**THE IMPROVEMENTS OF
PROCTOR ROAD
FROM REDWOOD ROAD TO CAMINO ALTA MIRA
CASTRO VALLEY, ALAMEDA COUNTY, CALIFORNIA
SPECIFICATION NO. 2491**

This addendum is issued by the County of Alameda, Public Works Agency, Construction and Development Services Department, 399 Elmhurst Street, Hayward, CA 94544.

Receipt of this Addendum No. 2 must be acknowledged on the form in the bid proposal in writing.

THE IMPROVEMENTS OF
PROCTOR ROAD
FROM REDWOOD ROAD TO CAMINO ALTA MIRA
STORM WATER POLLUTION
PREVENTION PLAN

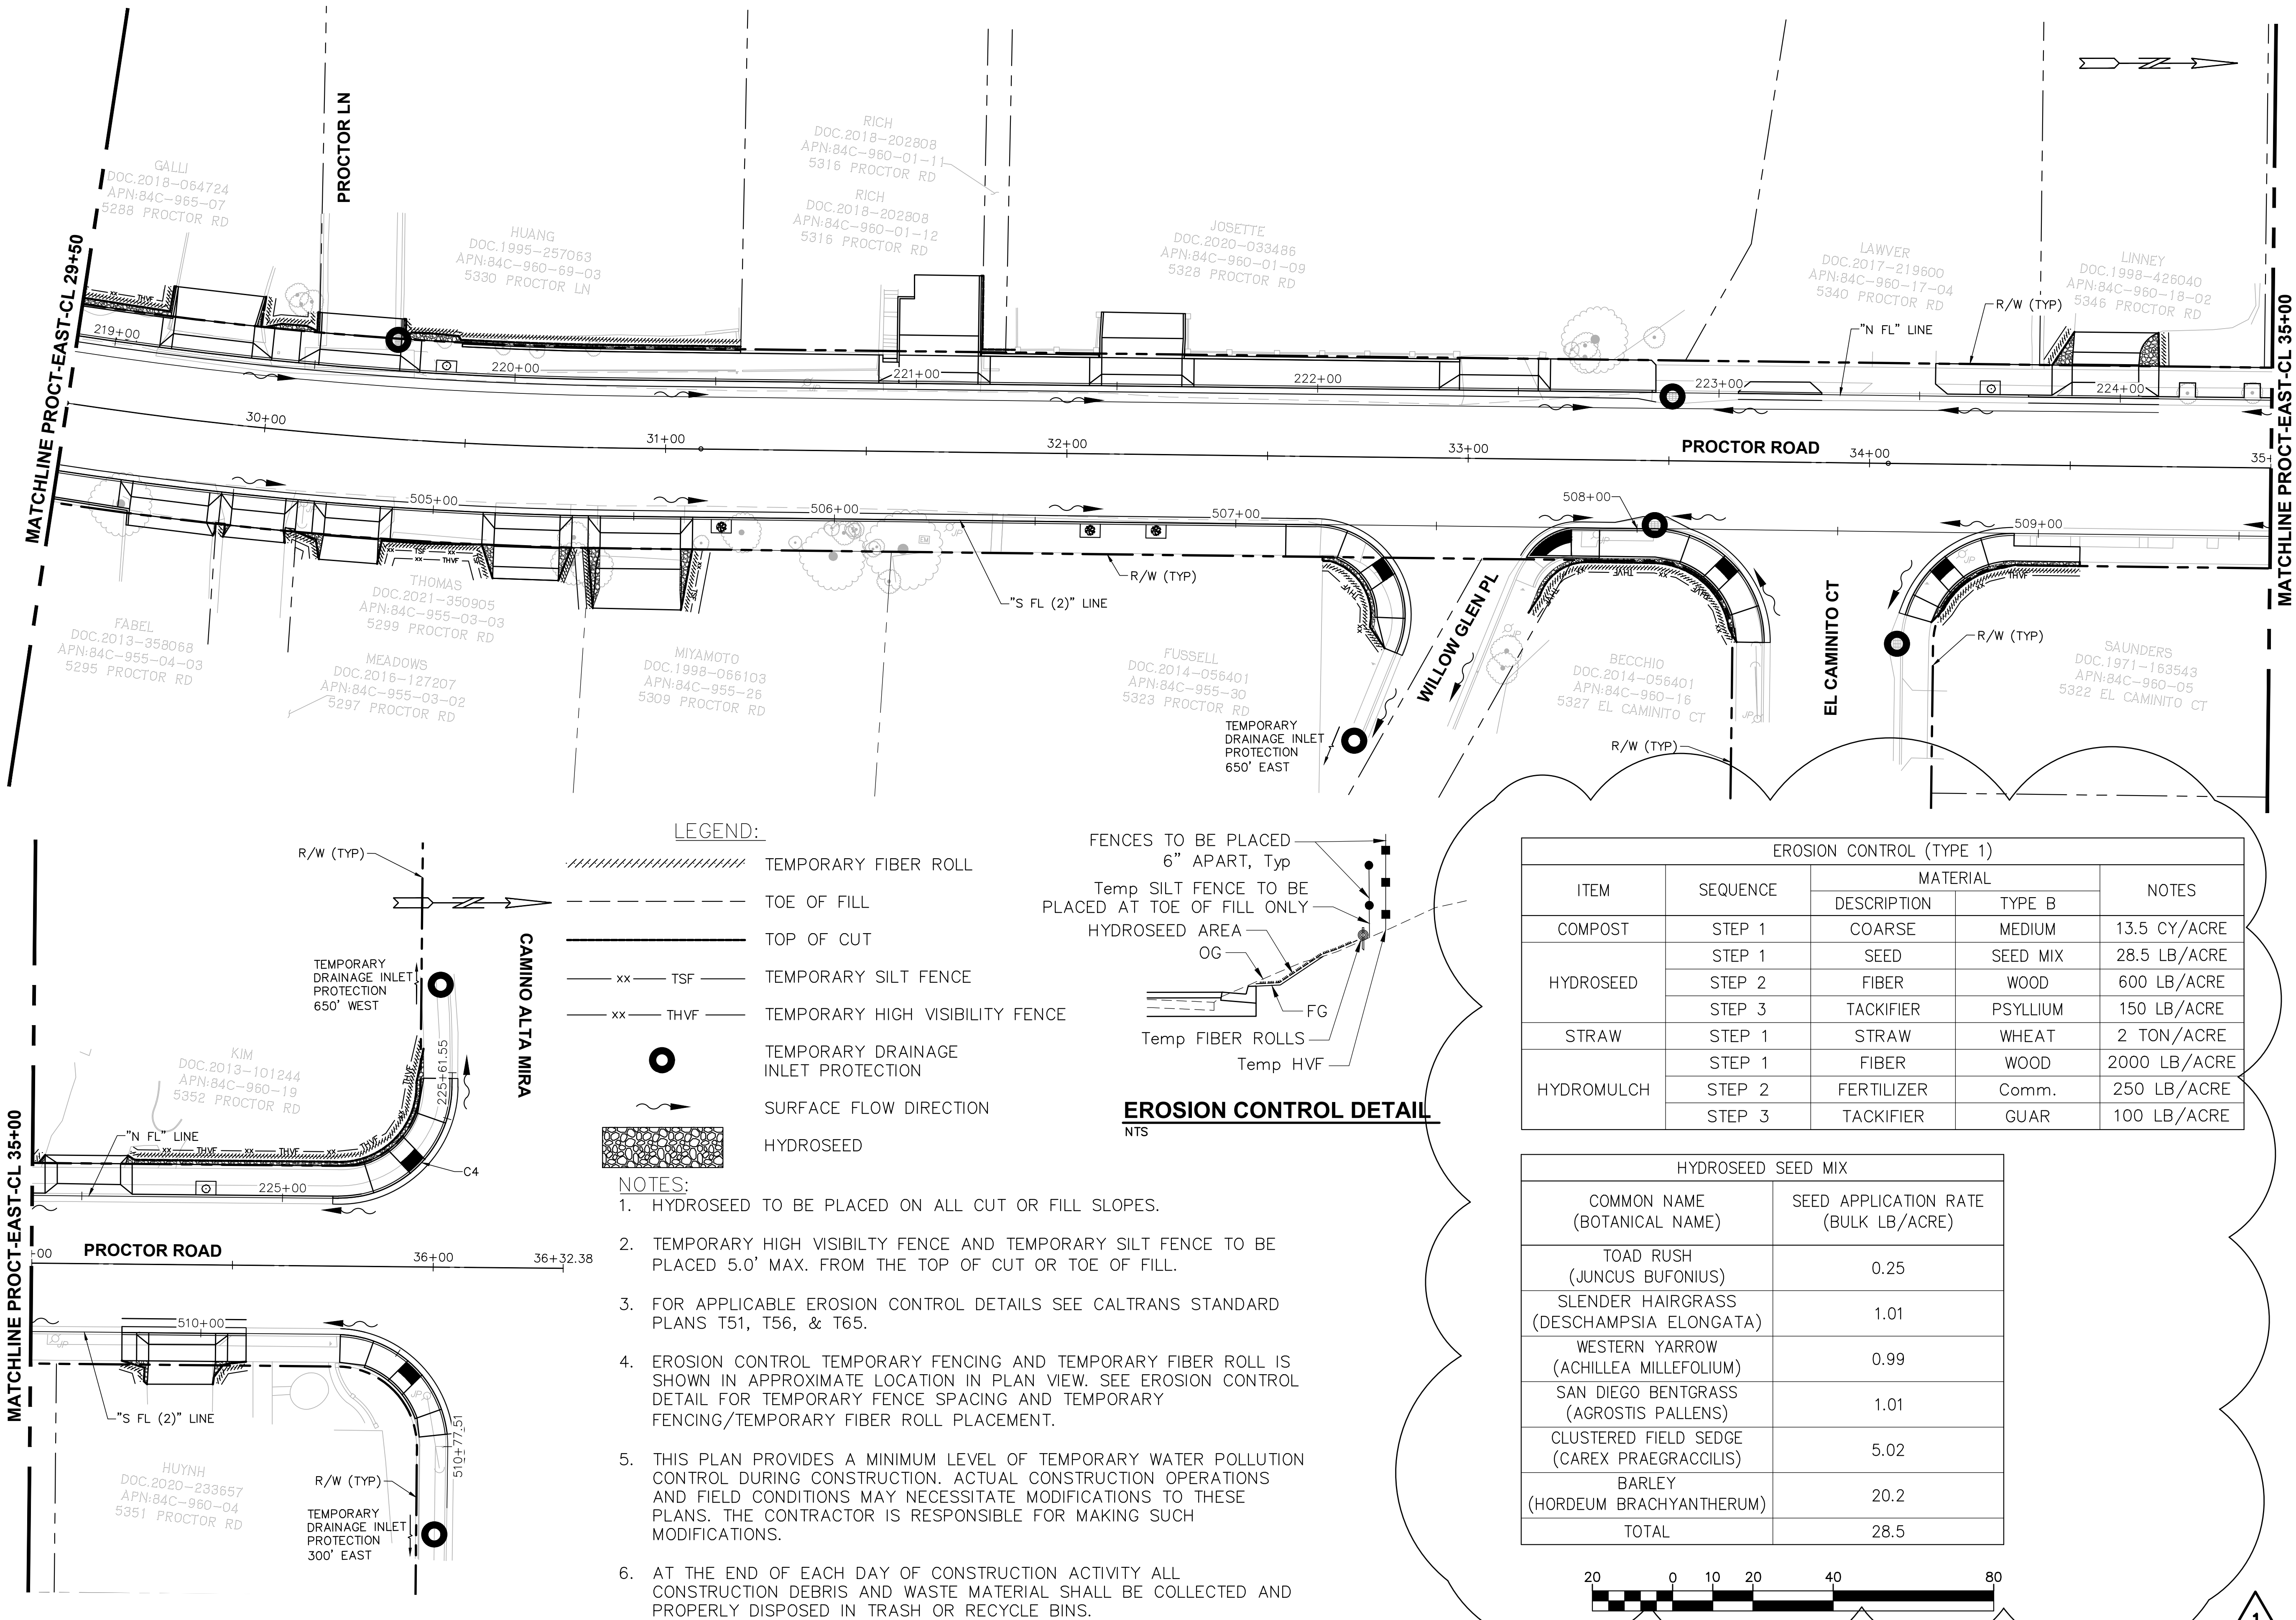
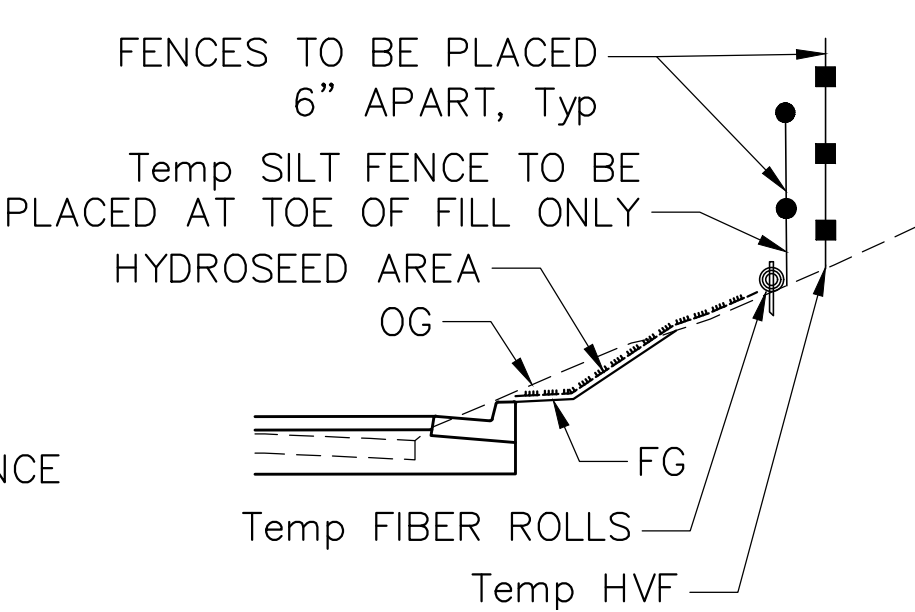
1. Replace Plan Sheet 4 with the attached Plan Sheet 4 (Addendum 2)
